**Proposal #03: 3653-00-70**  
**CTH S – CTH O**  
**Turtle Creek Bridge, B-53-0386**  
**CTH J**  
**Rock County**

This is Addendum No. 01, which provides for the following:

**Addendum No. 01**  
**ID 3653-00-70**  
**Revised Sheet 41**  
**July 27, 2021**

GENERAL PLAN  
SHEET 1 OF 15  
DATE: 41

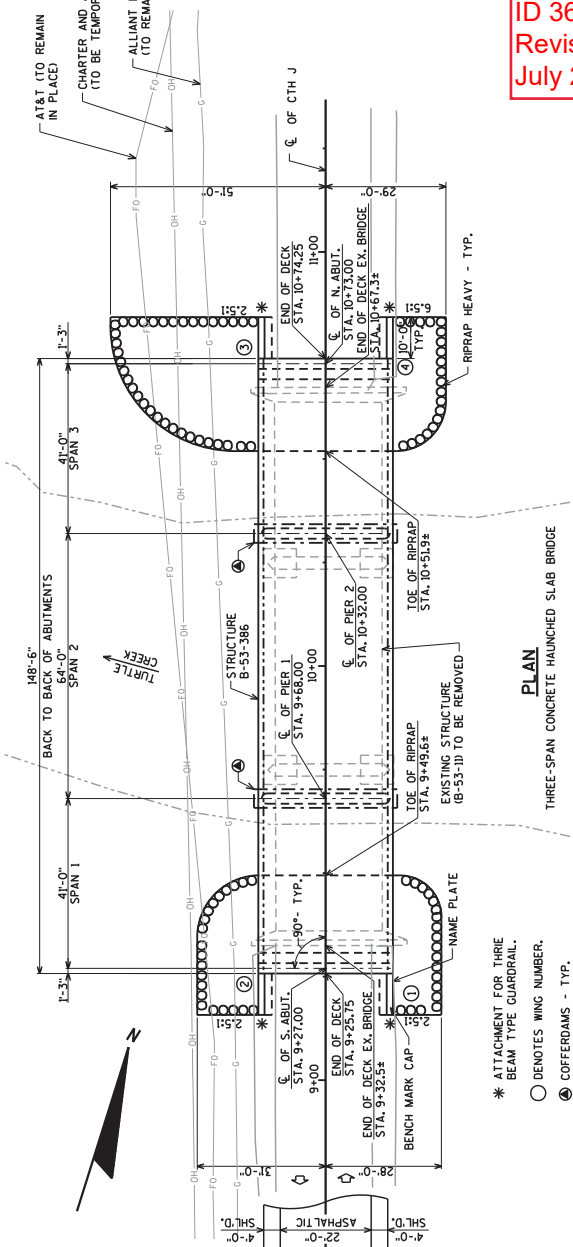
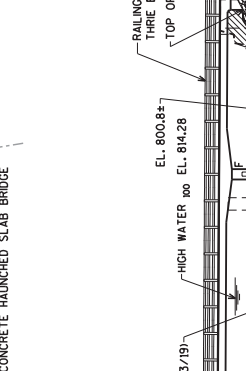
Revised Plan Sheets	
Plan Sheet	Plan Sheet Title (brief description of changes to sheet)
41	General Plan (Pile points removed and clarified that driving not required for pre-bored piles at piers)
42	Quantities and Notes (Revised pile point quantity)
43	Subsurface Exploration (Removed pile points at piers)
50	Pier 1 (Pile points removed and clarified that driving not required for pre-bored piles)
51	Pier 2 (Pile points removed and clarified that driving not required for pre-bored piles)

FOUNDATION DATA:  
ABUTMENTS TO BE SUPPORTED ON HP 10 x 42 STEEL PILING (WITH PILE POINTS) DRIVEN TO A REQUIRED DRIVING RESISTANCE OF 140 TONS ± PER PILE AS DETERMINED BY THE LOGGED DRIVING RESISTANCE (LOGGED TO 25' BELOW THE PILE POINTS).  
PIERS TO BE SUPPORTED ON HP 10 x 42 STEEL PILING (WITH PILE POINTS) DRIVEN TO A REQUIRED DRIVING RESISTANCE OF 140 TONS ± PER PILE AS DETERMINED BY THE LOGGED DRIVING RESISTANCE (LOGGED TO 25' BELOW THE PILE POINTS).  
\* THE FACTORED AXIAL RESISTANCE OF PILES IN COMPRESSION USED FOR DESIGN IS THE REQUIRED DRIVING RESISTANCE MULTIPLIED BY A RESISTANCE FACTOR OF 0.5 USING MODIFIED GATES TO DETERMINE DRIVEN PILE CAPACITY.

PIER 1

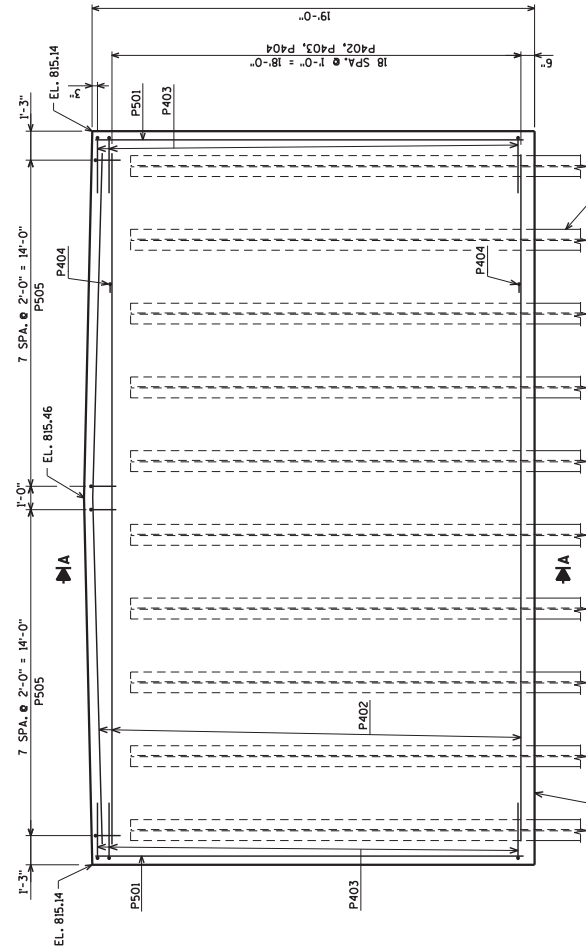
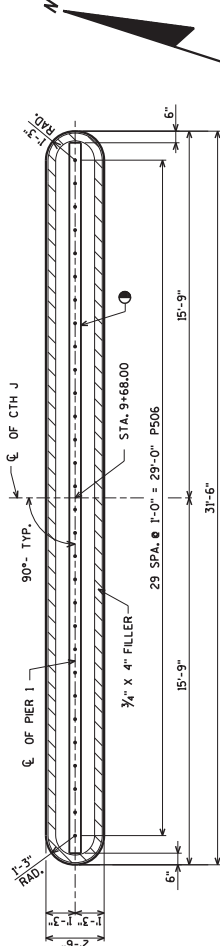
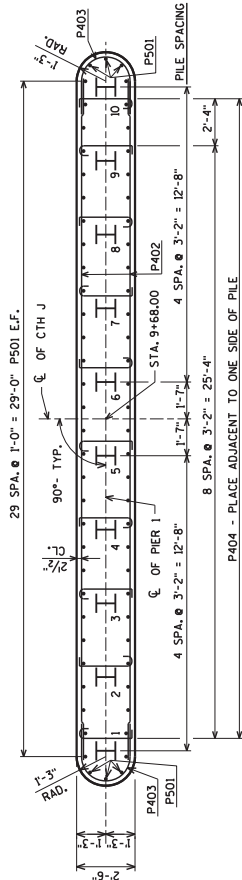
PIER TO BE SUPPORTED ON HP 10 X 42 STEEL PILING WITH PILE POINTS DRIVEN TO A RECORD-DRAWING RESISTANCE OF 180 TONS PER PILE. ESTIMATED LENGTH 26'-0". PRE-BORE PILING 10'-0".

PIER 2

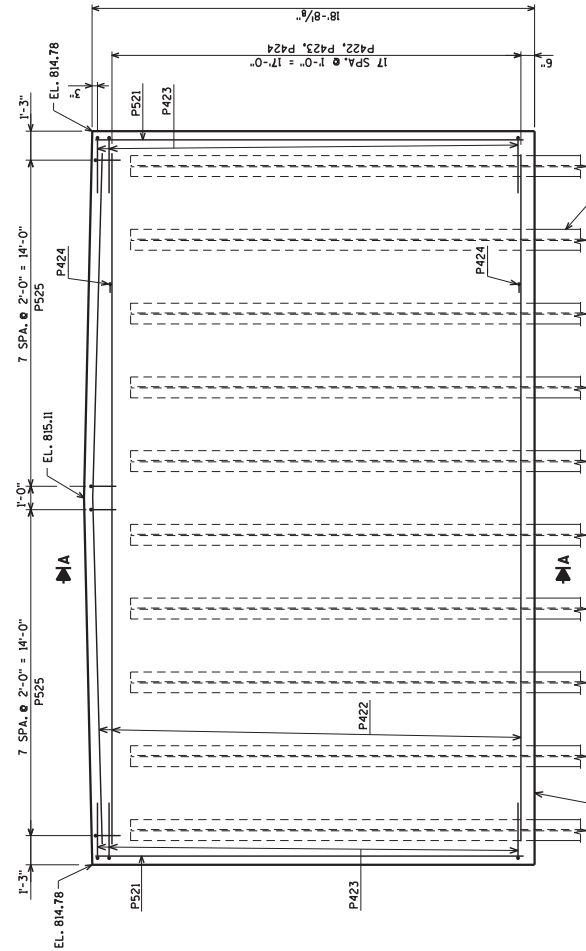
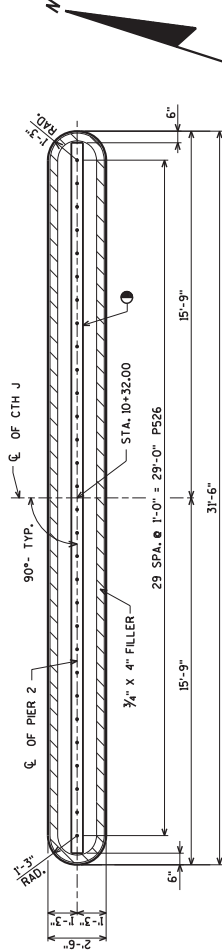
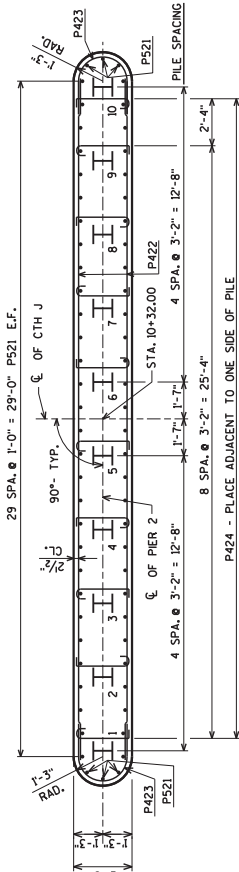
PIER TO BE SUPPORTED ON HP 10 X 42 STEEL PILING WITH PILE POINTS DRIVEN TO A RECORD-DRAWING RESISTANCE OF 180 TONS PER PILE. ESTIMATED LENGTH 26'-0". PRE-BORE PILING 10'-0".
